Access Compliance Report

Public Rights-of-Way

Intersection ID: 6300	Main Street: JORDANS_POND_LN	Cross Street: VALLEYDALE_RD	Location:	N
ADA ID: F75B4DF0772B	Ramp Type: PerpDiag	Initial Pass/Fail: Fail	Overall Compliance: No	Severity Score: 12.5

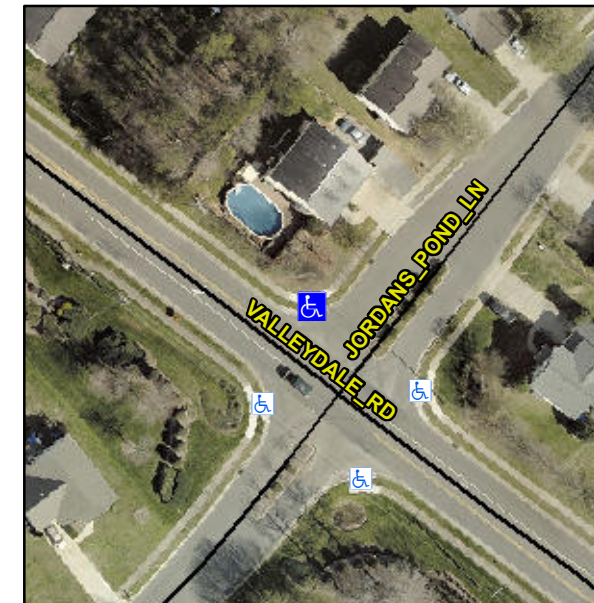
Not Found, R304.2.2

Compliance	Description	Data	Compliance	Description	Data
N/A	Ramp Length (in)	48.0	No	Ramp Slope (%)	8.5
Yes	Ramp Width (in)	48.0	Yes	Ramp XSlope (%)	0.5
N/A	Flare Type LT	N/A	N/A	Flare Type RT	N/A
N/A	Flare Slope LT (%)	N/A	N/A	Flare Slope RT (%)	N/A
N/A	Flare Traversable LT?	N/A	N/A	Flare Traversable RT?	N/A
N/A	Landing Length (in)	N/A	N/A	DWS Provided?	N/A
N/A	Landing Width (in)	N/A	N/A	DWS Contrast?	N/A
N/A	Landing Slope (%)	N/A	N/A	DWS Length (in)	N/A
N/A	Landing X Slope (%)	N/A	N/A	DWS Full Width?	N/A
N/A	Landing Curb? (Y/N)	N/A	N/A	DWS Offset (in)	N/A
N/A	Shared Landing?	N/A			
N/A	Gutter Ponding?	N/A	N/A	Gutter Slope (%)	N/A
N/A	Gutter Lip Ht (in)	N/A	N/A	Gutter X Slope (%)	N/A
N/A	Painted X Walk1?	No	N/A	Painted X Walk2?	No
	X Walk 1 Direction	To SW		X Walk 2 Direction	To SE
N/A	X Walk 1 Width (in)	N/A	N/A	X Walk 2 Width (in)	N/A
	X Walk 1 Slope (%)	4.9		X Walk 2 Slope (%)	4.3
	X Walk 1 X Slope (%)	3.0		X Walk 2 X Slope (%)	1.7

Remove & Replace Curb Ramp With Two New Directional Ramps or Equivalent.
